# Access Compliance Report Public Rights-of-Way (Curb Ramps)

**Main Street:** THISTLE\_RD      **Cross Street:** RAMM\_DR      **Location:** N

**ADA ID:** RPRK210924172140      **Ramp Type:** Type 6 - Directional 1      **Initial Pass/Fail:** Fail      **Overall Compliance:** No      **Severity Score:** 2

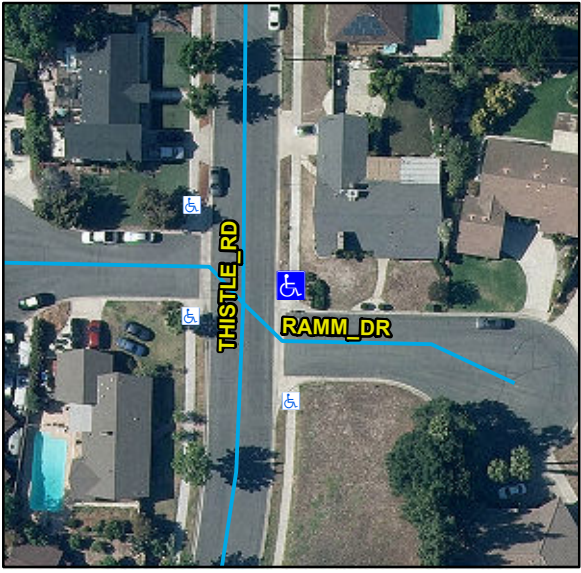
Compliance	Description	Data	Compliance	Description	Data
N/A	Ramp Length (in)	103	N/A	Flare Type LT	
Yes	Ramp Width (in)	60			N/A
Yes	Ramp Run Slope (%)	5.6	N/A	Flare Slope LT (%)	N/A
No	Ramp Cross Slope (%)	4	N/A	Flare Traversable LT	N/A
N/A	Grade Break	N/A	N/A	Flare Type RT	
N/A	Grade Break Slope (%)	N/A			N/A
N/A	Grade Break Cross Slope (%)	N/A	N/A	Flare Slope RT (%)	N/A
	Addl Para Ramp Left?	No	N/A	Flare Traversable RT	N/A
	Addl Para Ramp Right?	No	N/A	DWS Provided	N/A
N/A	Landing Present	N/A	N/A	DWS Contrast	N/A
N/A	Landing Length (in)	N/A	N/A	DWS Length (in)	N/A
N/A	Landing Width (in)	N/A	N/A	DWS Full Width	N/A
N/A	Landing Run Slope (%)	N/A		DWS Offset Type	N/A
N/A	Landing Cross Slope (%)	N/A	N/A	DWS Left Offset (in)	N/A
N/A	Landing Movement Obstructed?	N/A	N/A	DWS Right Offset (in)	N/A
	Landing Movement Type	N/A			
N/A	Landing Shared	N/A			
N/A	Marked Crosswalk 1	No	N/A	Clear Space	Yes
	Crossing 1 Direction	W	N/A	Clear Space To Crosswalk (in)	N/A

Marked Crosswalk 1 Width (in)	N/A			
N/A	Ramp Inside Crosswalk 1	N/A			
	Crossing 1 Slope (%)	8.4			
	Crossing 1 Cross Slope (%)	1.5			
N/A	Gutter Ponding	N/A	N/A	Curb Slope	1
Yes	Gutter Lip Height (in)	0		Road Run Slope (%)	1
N/A	Gutter Run Slope (%)	N/A		Road Cross Slope (%)	0.8
N/A	Gutter Cross Slope (%)	N/A		Parallel Ramp Side	Left
Yes	Overall Surface Condition	Acceptable	Yes	Perp Joint Present	Yes
	Cross Gutter Present?	Yes		Spandrel Present?	Yes
	Replace Cross Gutter?	No		Replace Spandrel?	No

**Possible Solutions:**  
**Remove & Replace Curb Ramp With Two New Directional Ramps or Equivalent.**

**OC Std/PROW:**  
**R304.5.3, STD 1115**
